SUBJECT: Triangle Expressway Southeast Extension (Complete 540) from NC 55

STIP Project Nos. R-2721, R-2828, and R-2829

Also, please reference your October 28, 2025, email, requesting modification of the permit to authorize change of impacts at Permit Sites 3, 5, 9, 12, and 13, for R-2829A. The modifications are necessary for in-field design revisions, including relocation of multiple utilities. The authorized additional impacts for this modification are as described below in Tables 1 & 2 below:

Action ID SAW-2009-02240; Complete 540; TIPS R-2721, R-2828, and R-2829

PERMIT DRAWING SHEET 23 OF 103

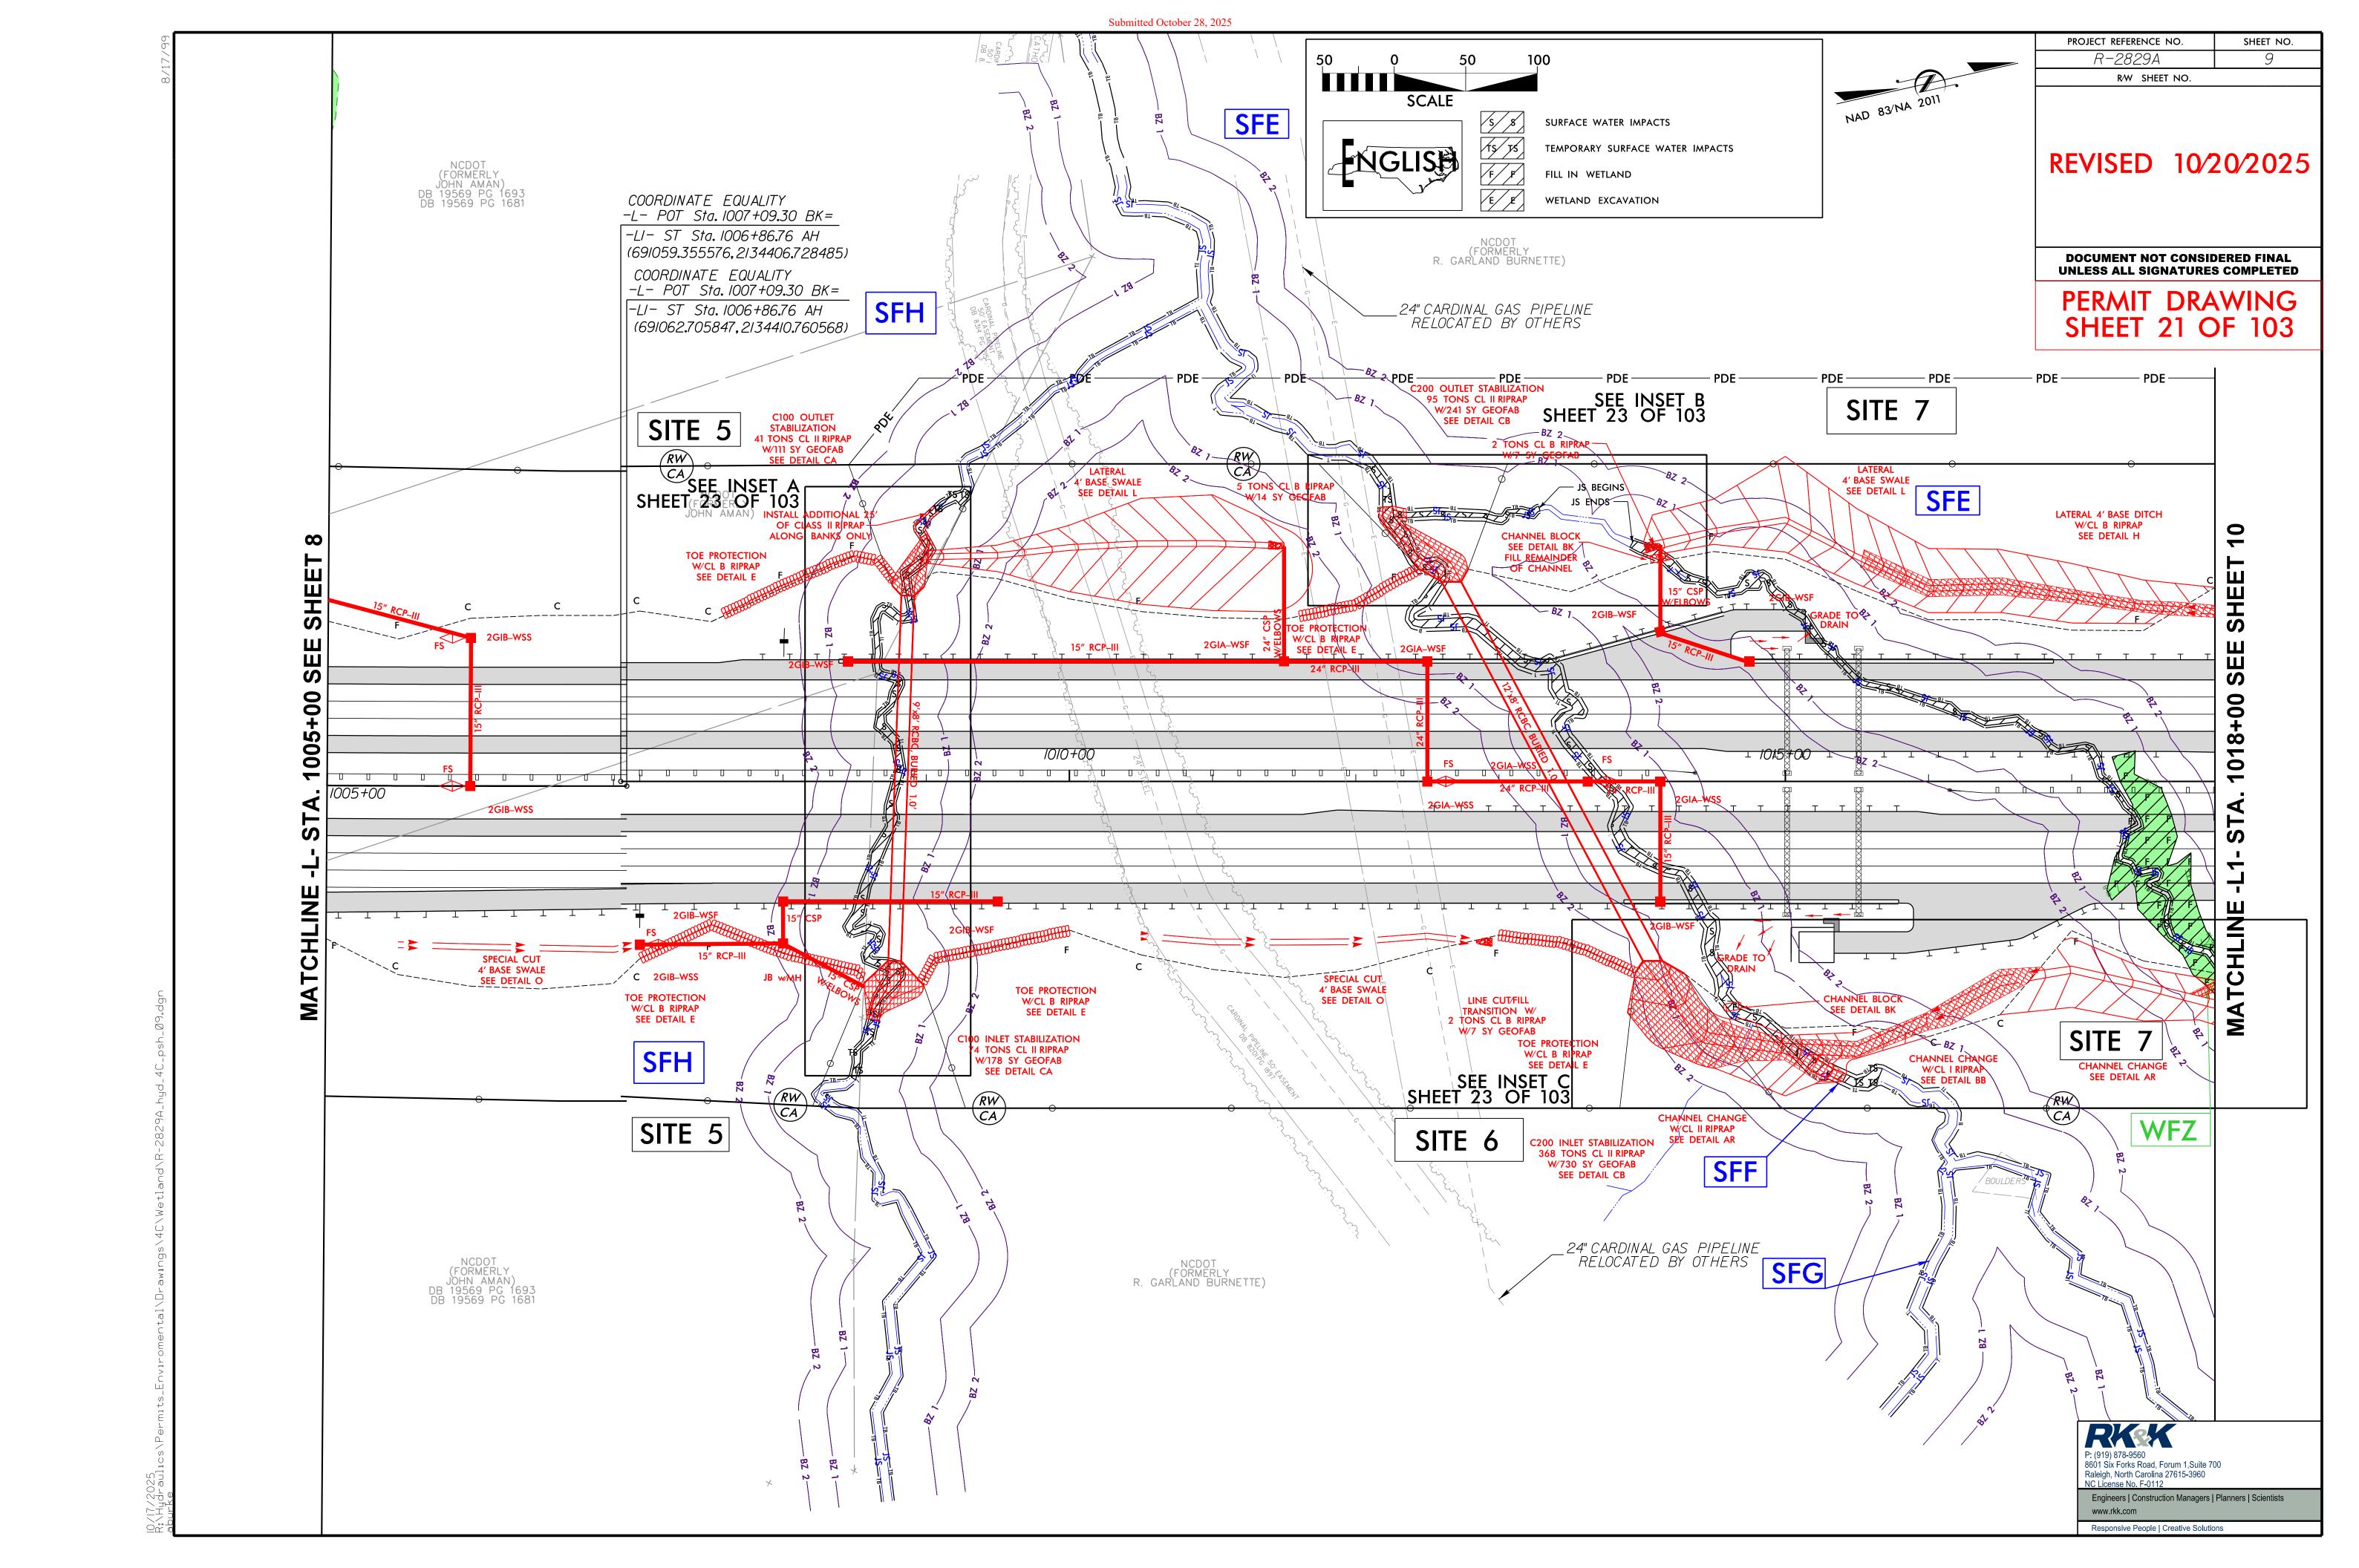
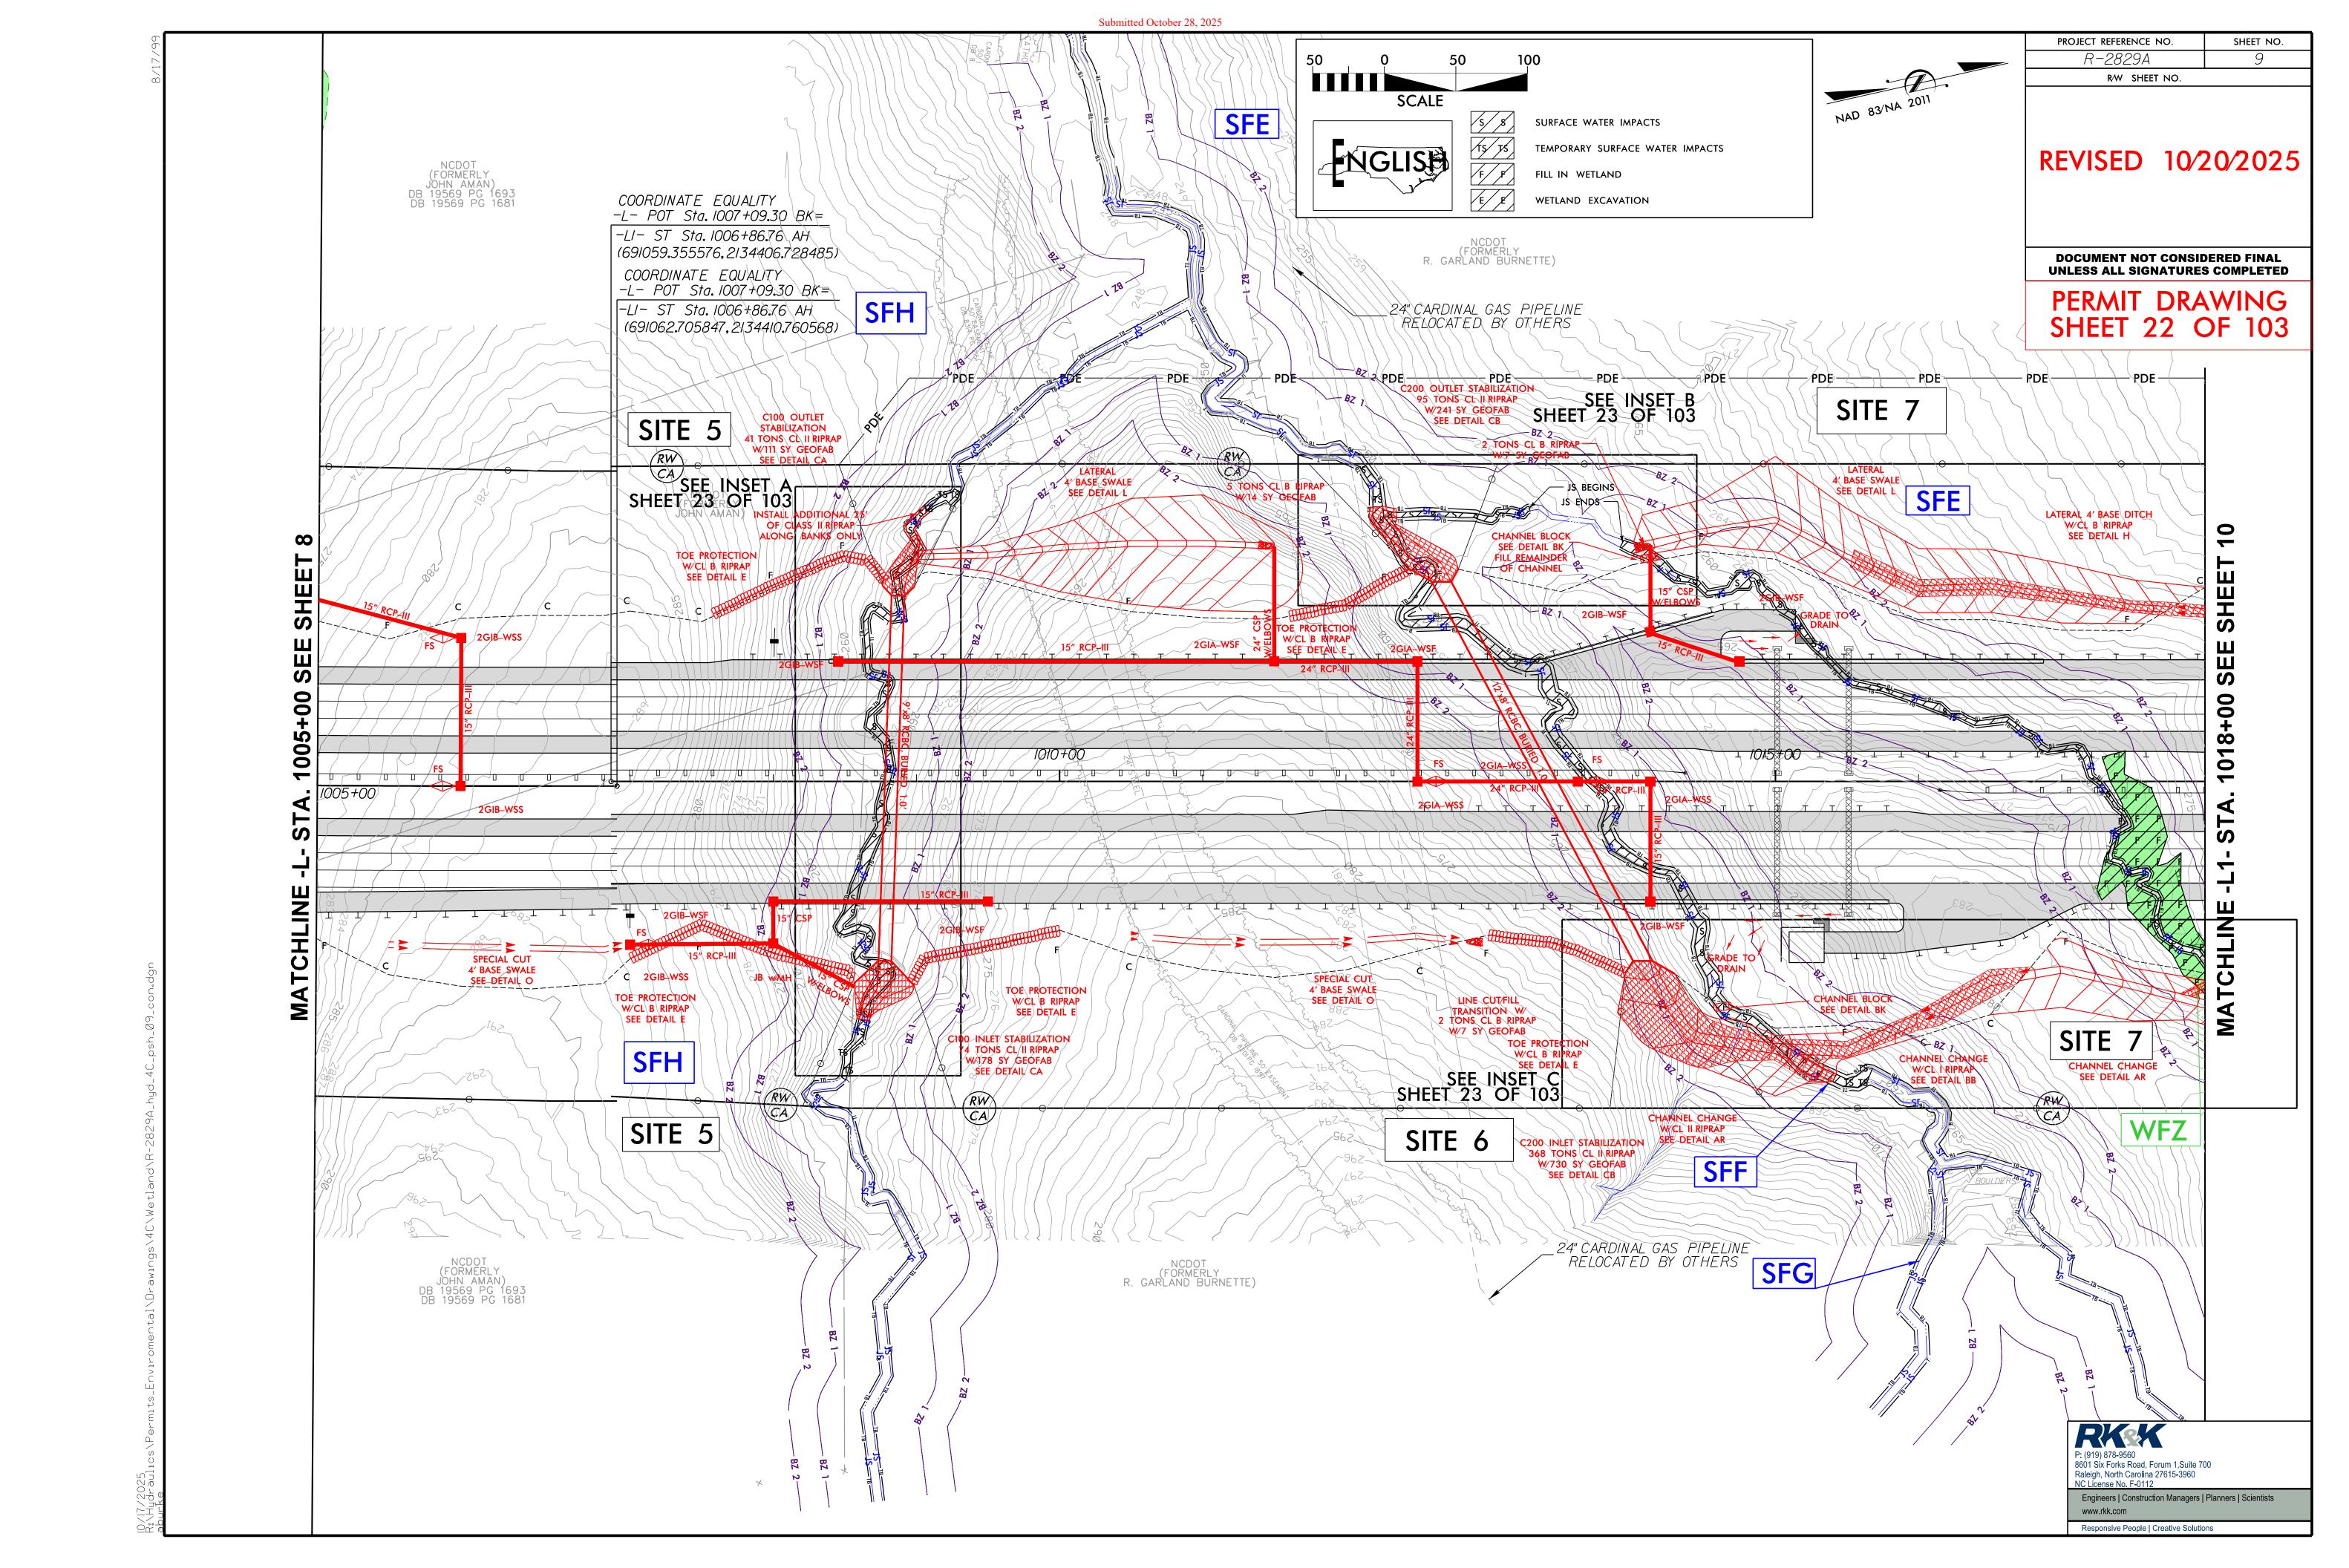
ADDITIONAL 25'
ASS II RIPRAP

BANKS ONLY
